**City of Portland, Maine - Building or Use Permit Application**

Permit No: 04-0783	Issue Date: JUL 2 2 2004	CBL: 061 E008001
-----------------------	-----------------------------	---------------------

Proposed Project Description:  
amendment to existing permit-add 10'x13' sunroom

DANFORTH STREET

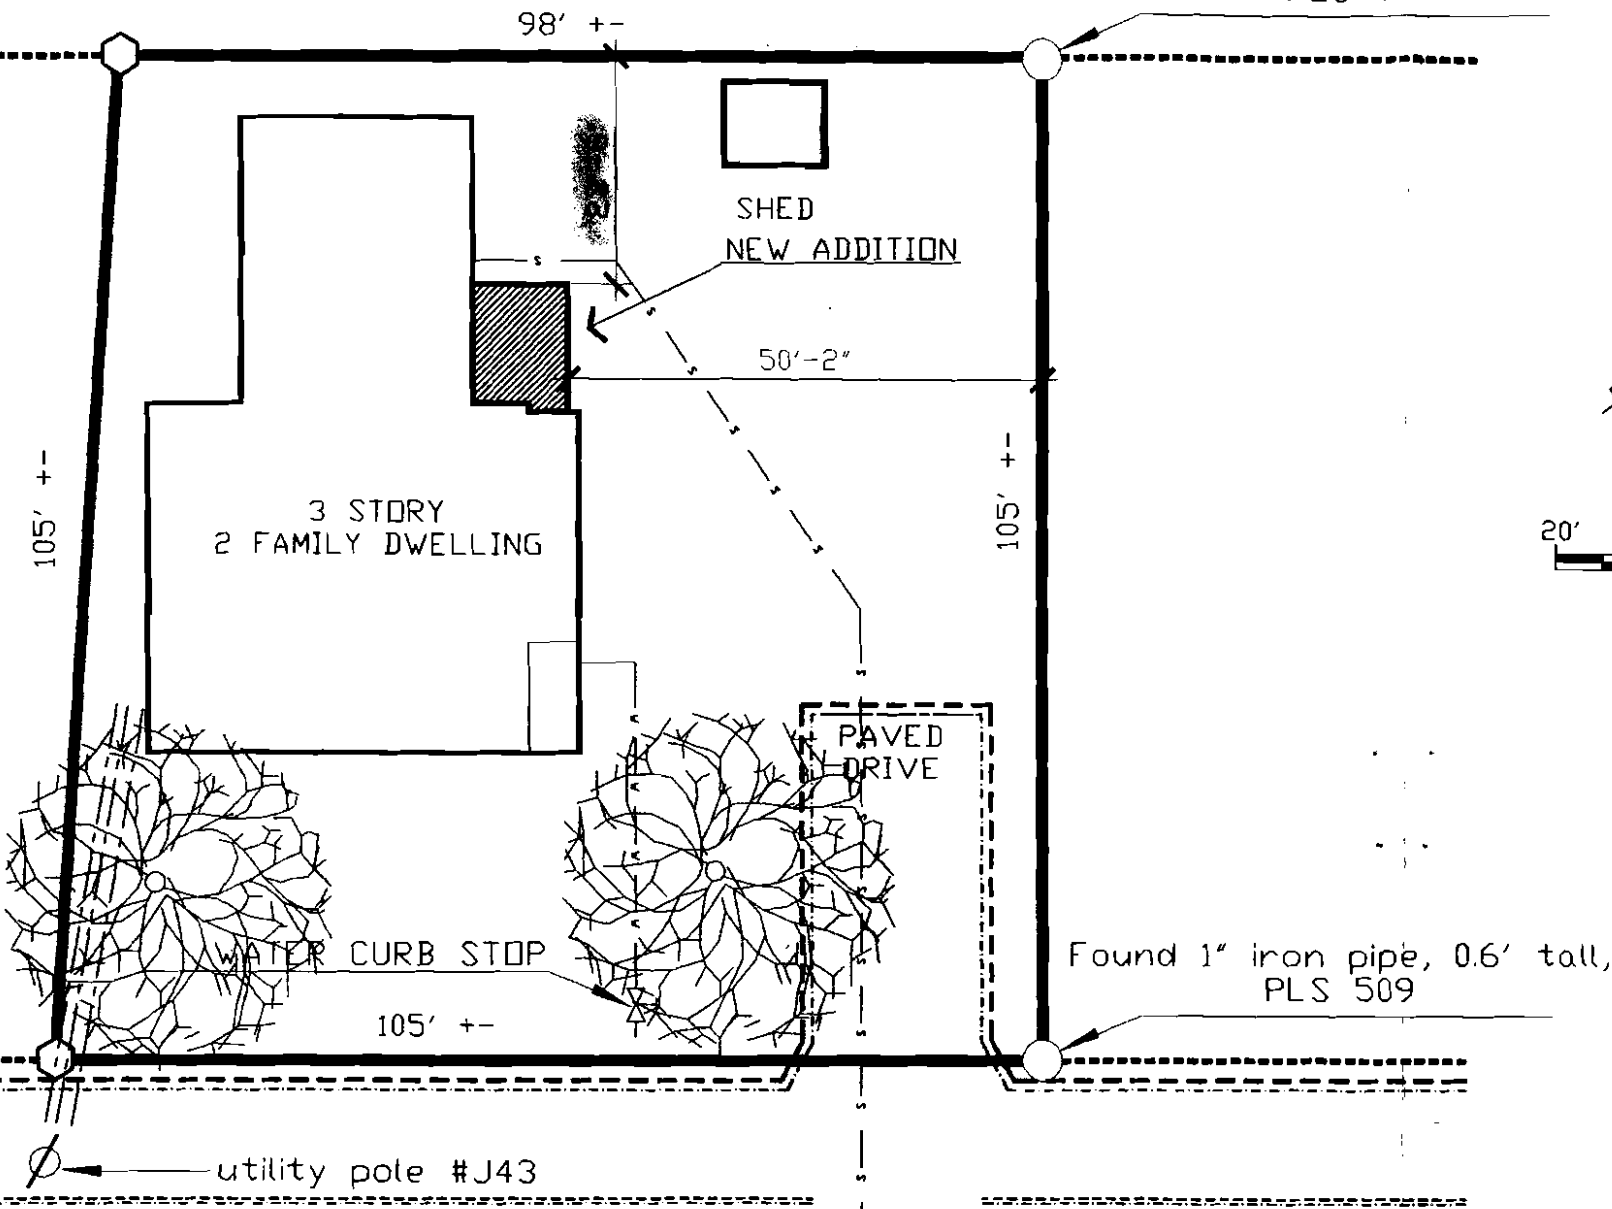
7/20/04 setbacks okay 23'8" - plans are 13'3" to  
outside edge of masonry - will check w/ TAM - go  
13'3" will be okay - backfill okay

<b>Dept:</b> Zoning	<b>Status:</b> Approved with Conditions	<b>Reviewer:</b> Marge Schmuckal	<b>Approval Date:</b> 07/12/2004
<b>Note:</b> 7/1/04 rear setback not being met [redacted] instead of the required 25' shown 7/12/04 Deb A. Gave me an e-mail - the project can met section 14-433 because of Historic criteria - Note codos approved under #03-0859			<b>Ok to Issue:</b> <input checked="" type="checkbox"/>

R-4 FEAR; 25' min req - 23' 8" shown OK  
 per 14-433-see memo  
 from D.A.

**Dear Marge:** At your request, I have reviewed Mr. Tacka's approved plans for a building addition to the rear ell of 387 Danforth Street. Reducing the size of the addition to meet the 25' rear yard setback would materially alter the approved design and, in my view, not meet Historic Preservation approval. Deb Andrews
